ADDENDUM NO. 02

November 14, 2025

To Drawings and Specifications dated October 24, 2025

Reynolds Elementary School Maintenance Improvements
Spring Independent School District

LOOSE VENEER LINTEL SCHEDULE

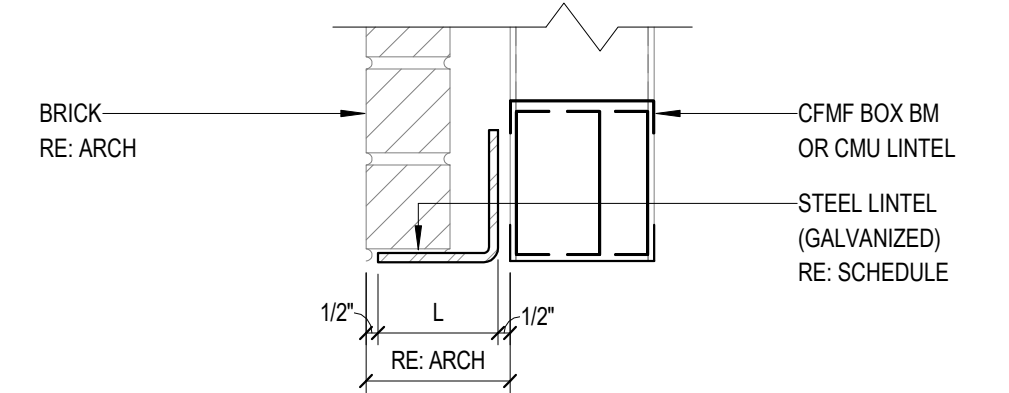
- Item No. 4 Sheet S101 General Structural Criteria
 - A. Discard and replace with enclosed.
 - B. Loose lintel schedule is added to sheet.
- Item No. 5 Sheet G-002, HCED Fire Code Sheet V9.0
 - C. Add enclosed sheet.
- Item No. 6 Sheet AD-700, Roof Plan - Demo
 - A. Discard and replace with enclosed.
- Item No. 7 Sheet AD-702, RCP - Demo
 - A. Add note "Refer to electrical drawings for demolition and replacement of light fixtures and wall mounted devices. Patch and restore surrounding surfaces as required."

ENLARGED PORTABLES PLAN

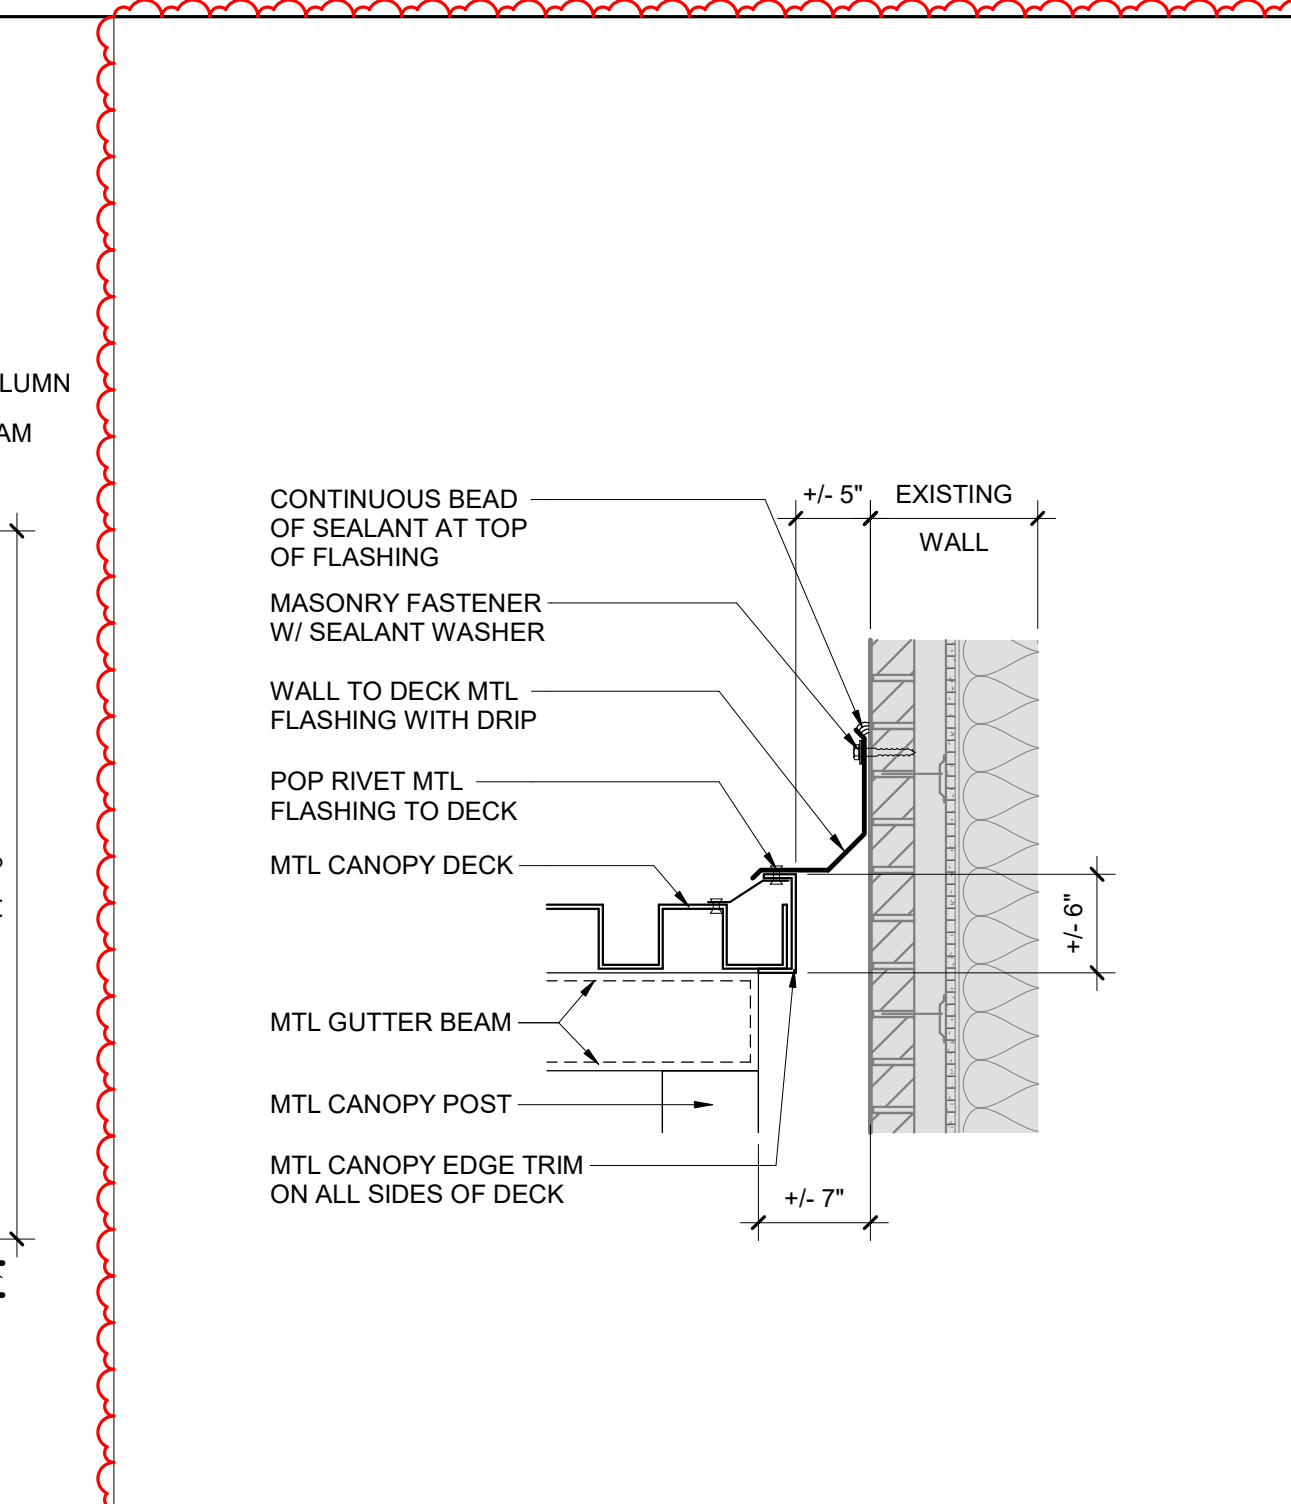
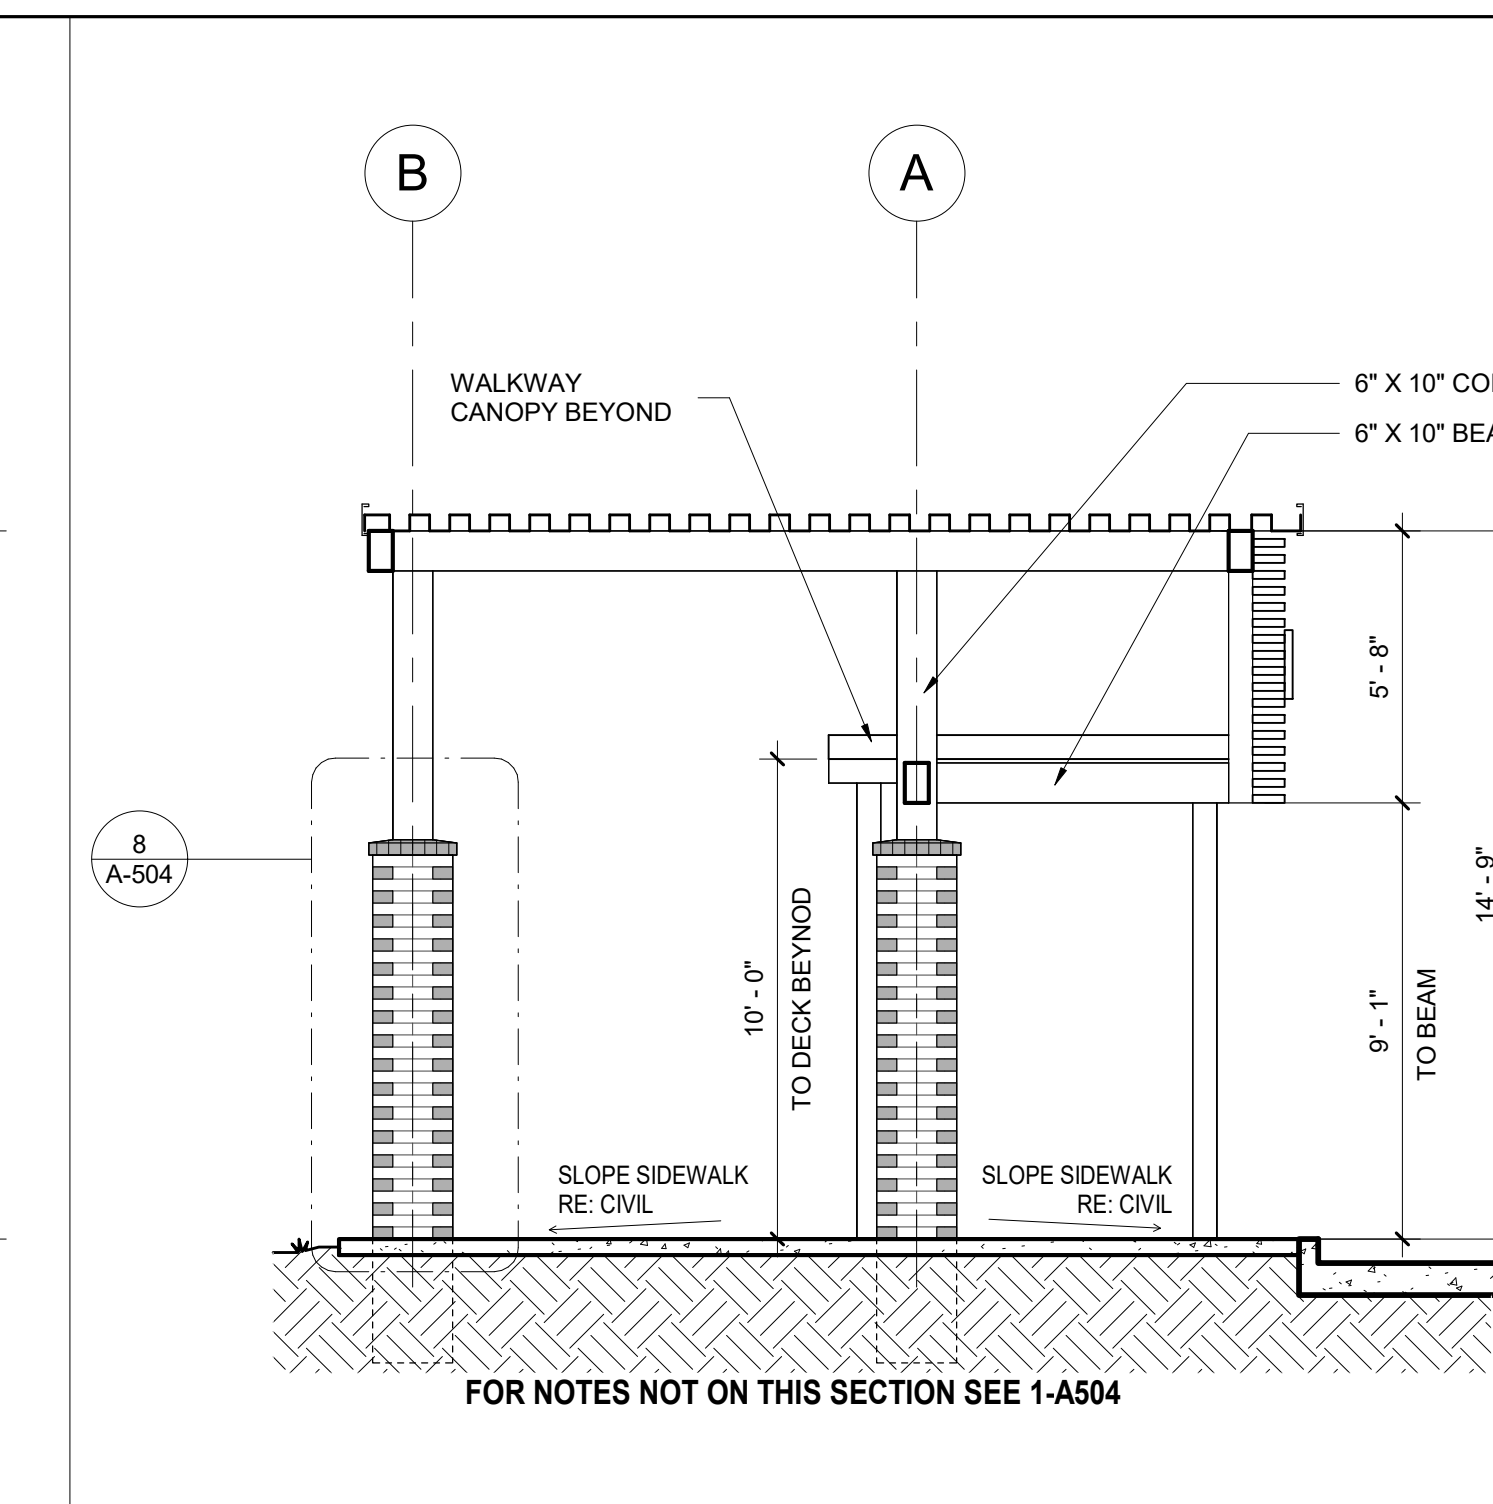
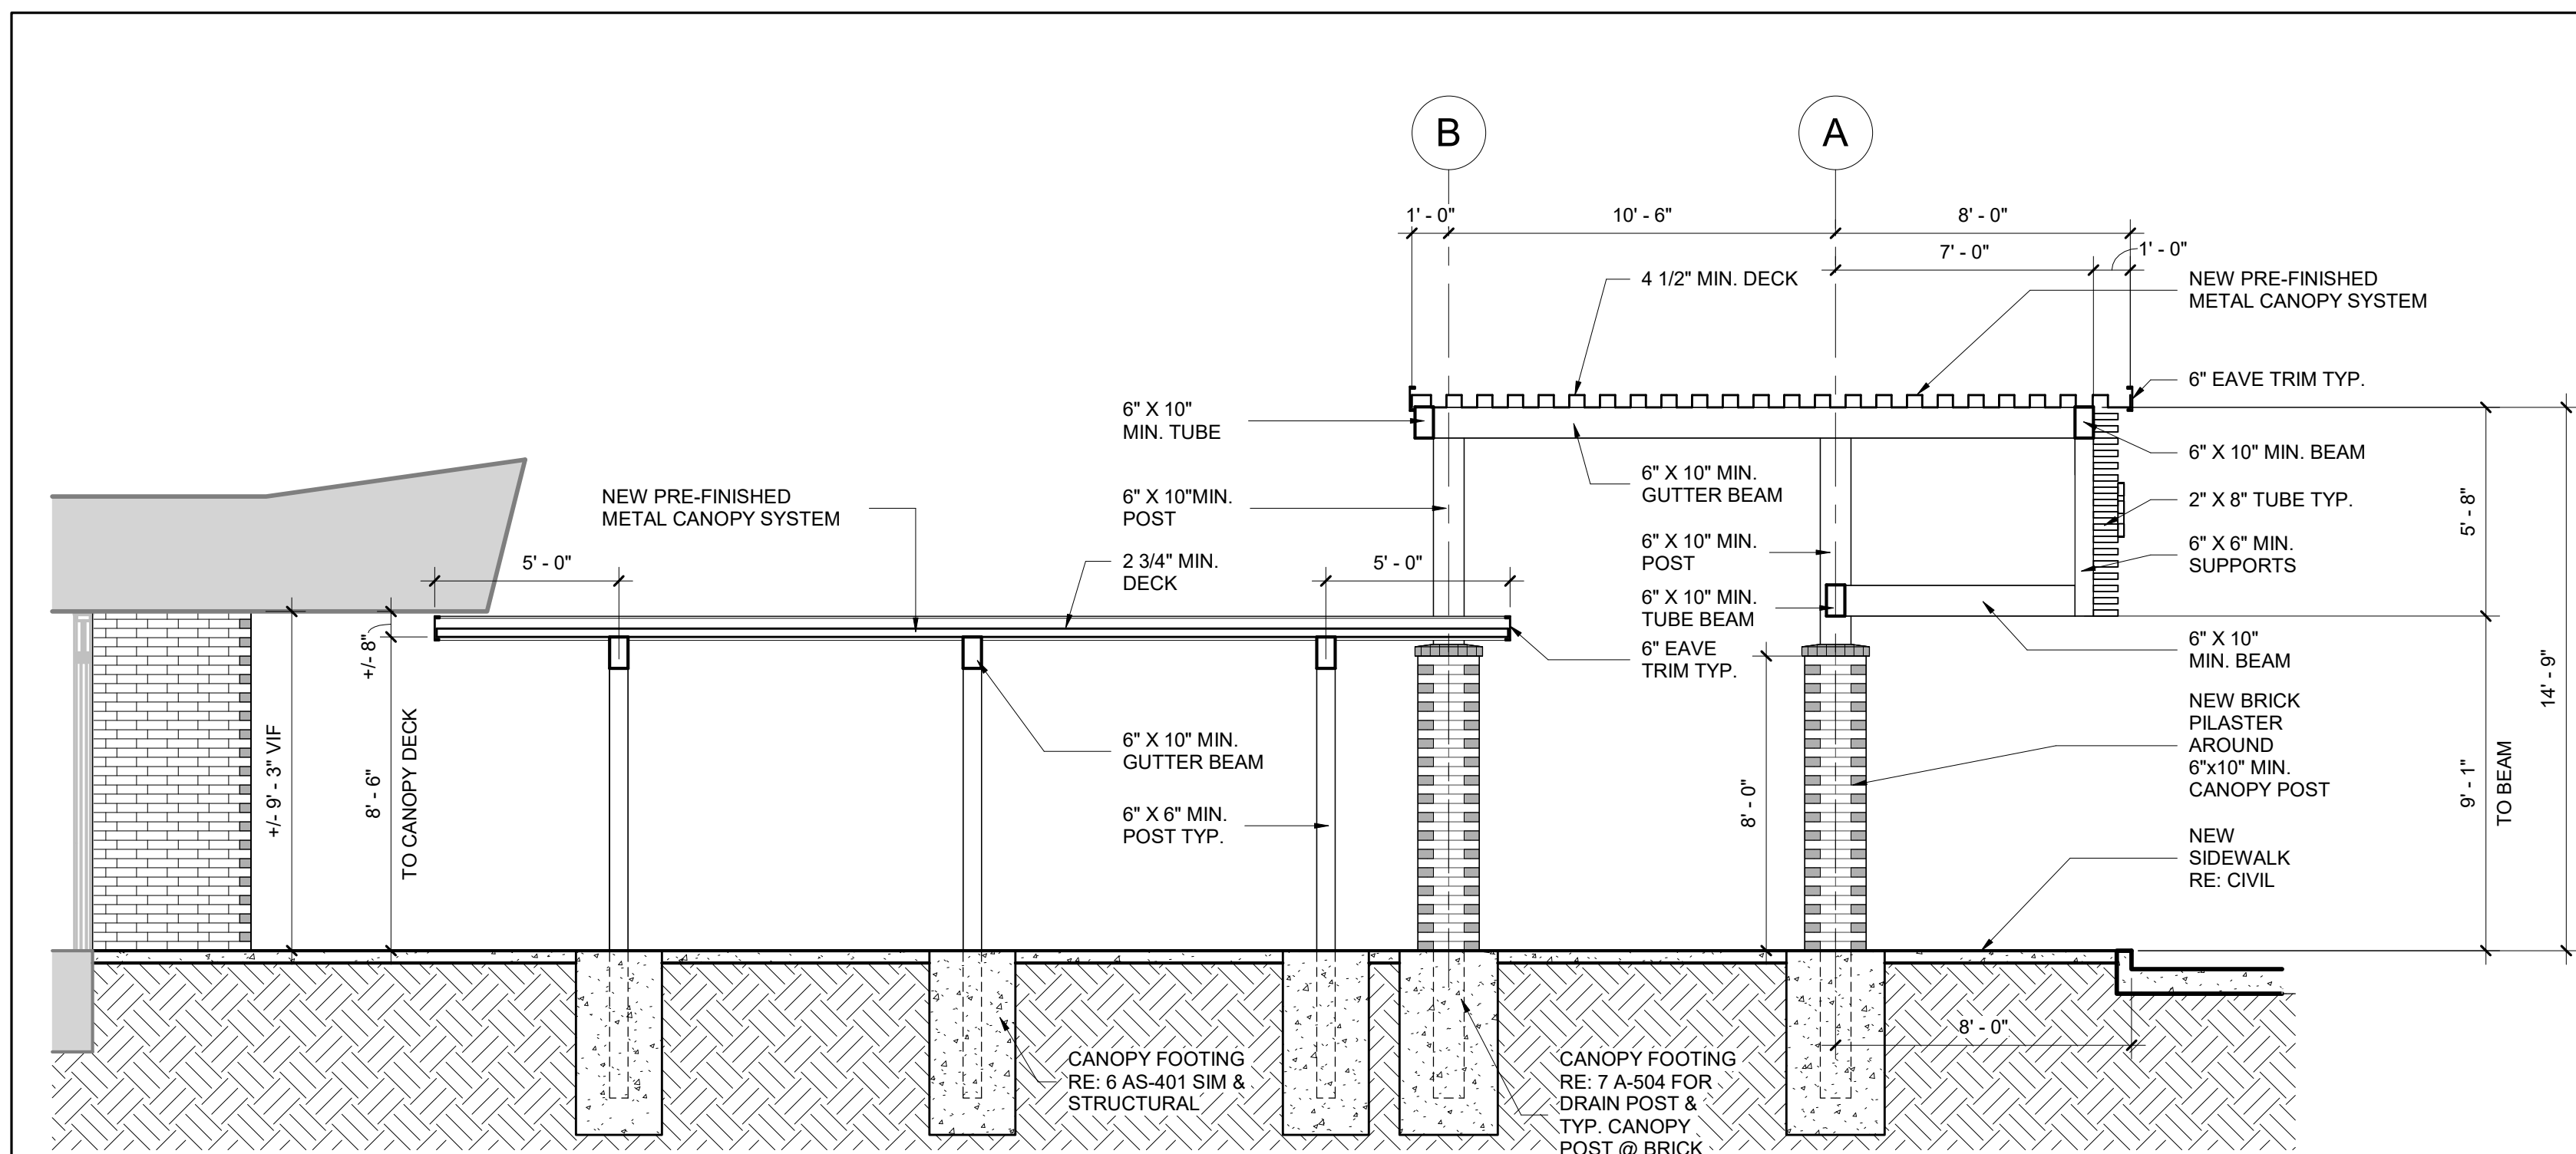
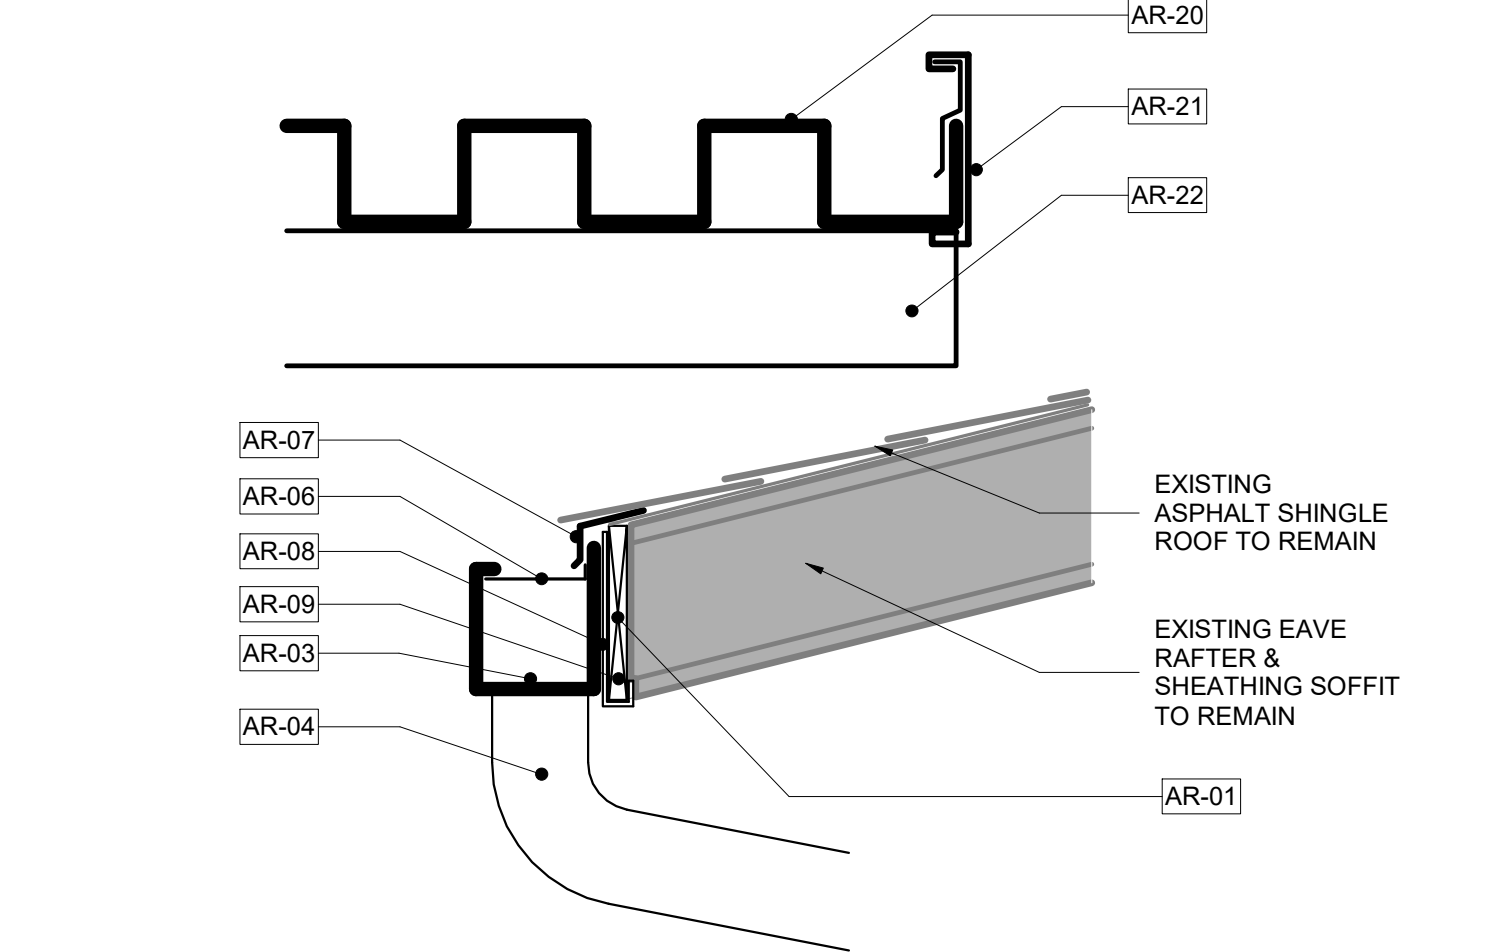
- Item No. 9 Sheet AS-401, Enlarged Portable Plan
 A. Discard and replace with enclosed.
 B. Add references to new detail 10.
- Item No. 10 Sheet A-502, Elevations, Sections and Details – Exterior wall
